Record of Appeal for Public Space Permit for 701 10th St NE

MEMORANDUM OF APPEAL

Re: Application for public space permit at 701 10th St., NE

Re: Appeal of public space permit (701 10th St., NE)

Exhibit A

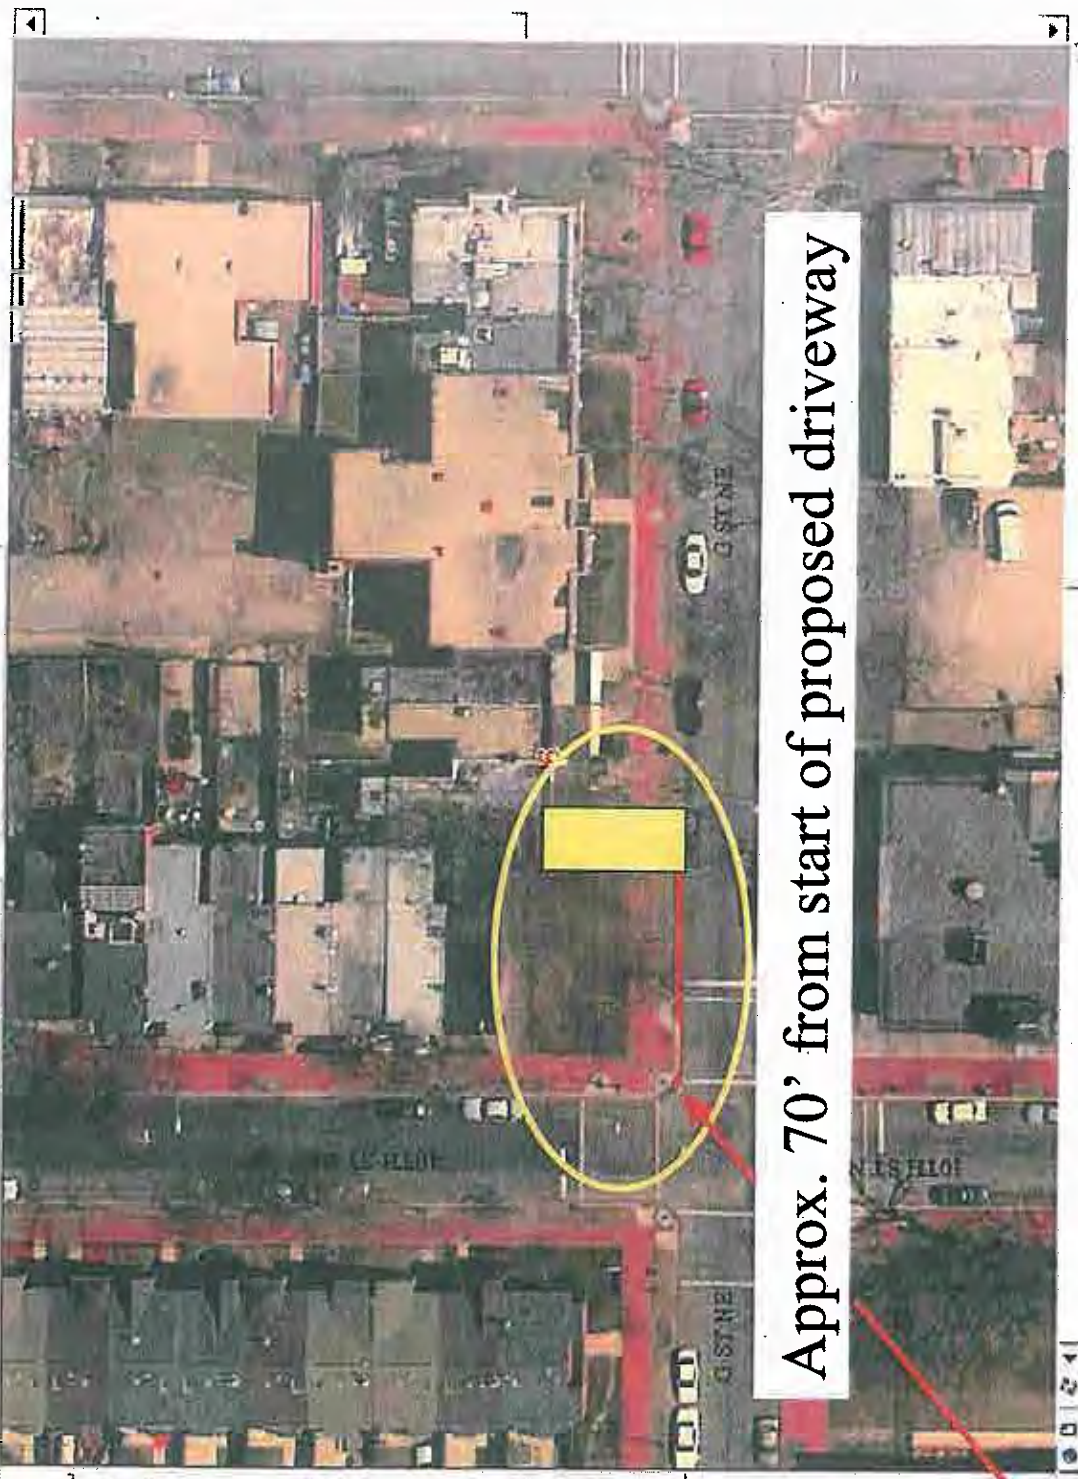
DDOT granted the Permit on the basis of incorrect measurements. All but one of the distance measurements in the administrative record were apparently taken on-site. Inexplicably, the only measurement for which DDOT relied on estimates from an electronic database instead of on-site measurements was the one for the distance from 10th Street, NE, to the edge of the proposed driveway. On the basis of this electronic estimate, DDOT concluded that the 10th Street, NE, intersection was “Approx. 70’ from start of proposed driveway.”¹

DDOT’s electronic estimate is grossly incorrect. The Contractor’s own Surveyor’s Plat shows that a 24-foot wide driveway will be somewhere between 30 ft. 11 in. and 47 ft. 8 in. from the intersection.² The actual measured physical distance from the intersection to the edge of the permitted driveway is, at most, 57 feet.³ In either case, the distance from the intersection to the

¹ See Exhibit A, attached. DDOT’s electronic approximation shows the driveway overlapping the neighboring property, which results in a greater distance between the intersection and proposed driveway.

Approx. 70' from start of proposed driveway

Exhibit B

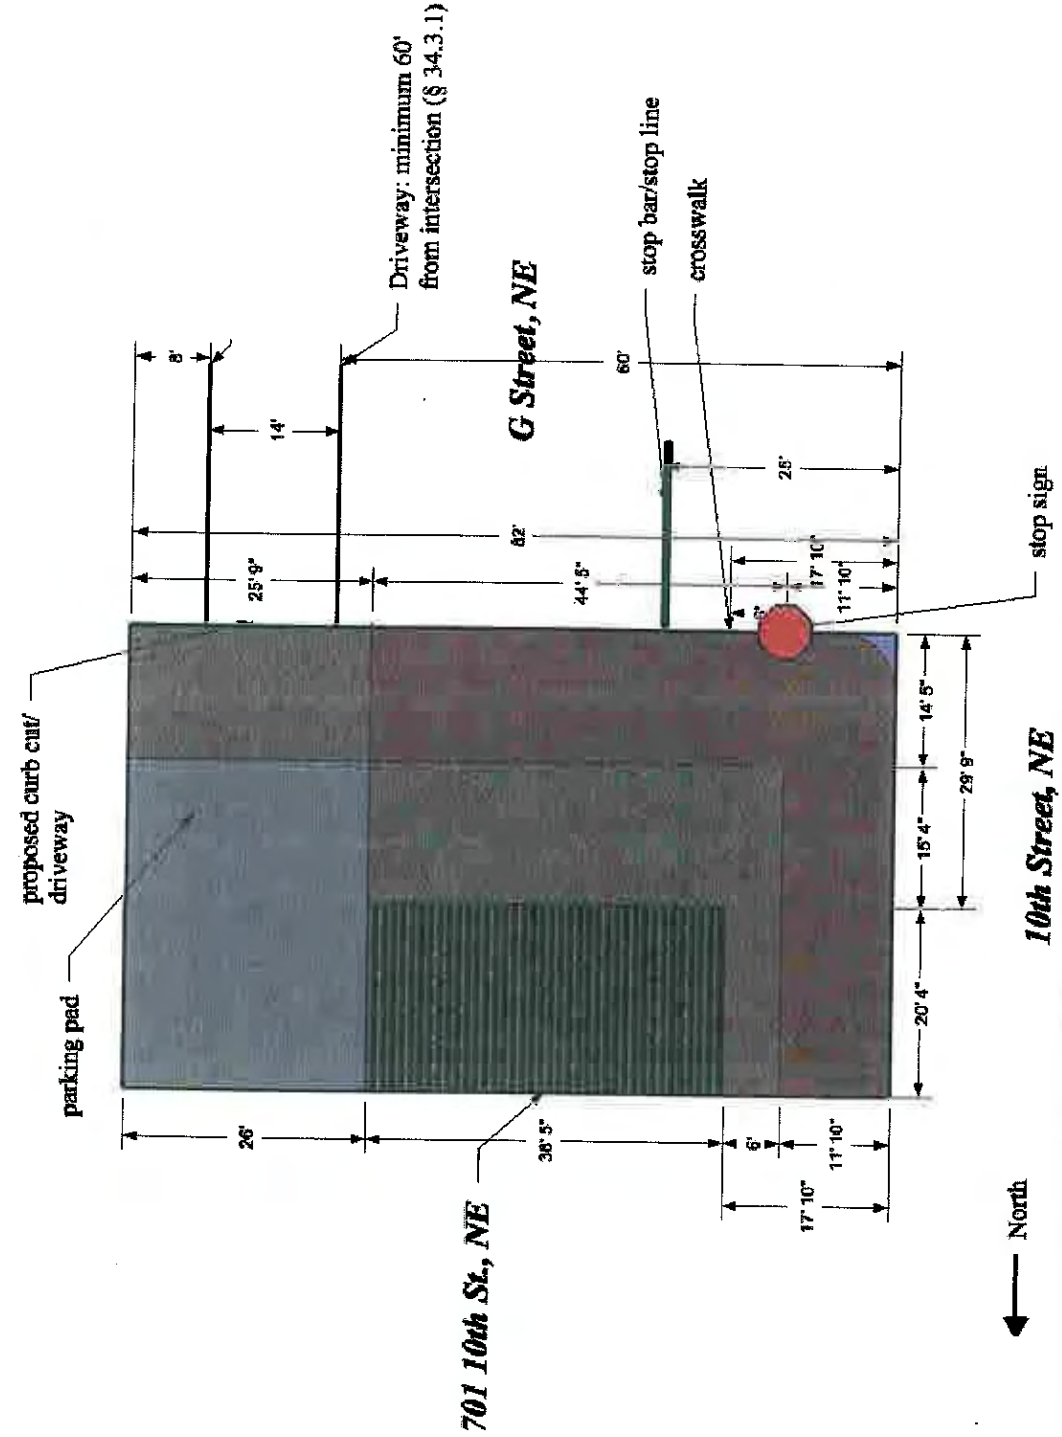
³ See Exhibit B (Diagram of Actual Measurements at 701 10th St., NE, enclosed).

The edge of any driveway must be a minimum of 60 feet from an intersection.⁸ In addition, in DDOT's consideration of the Permit application, DDOT's Traffic Services Administration ("TSA") determined that, in this case, "[t]he driveway must be a minimum of 25 feet [wide] so that both vehicles could move freely by each other" in the proposed two-car driveway.⁹ However, at the Property, the actual distance from the intersection at 10th St., NE, to the furthest

edge of the property line is only 82 ft. Therefore, any driveway that is 25 feet wide necessarily will fall within 60 feet of the intersection.¹⁰ In short, it is impossible for *any* two-car driveway at the Property to comply with both TSA's requirements and DDOT's Design and Engineering Manual.
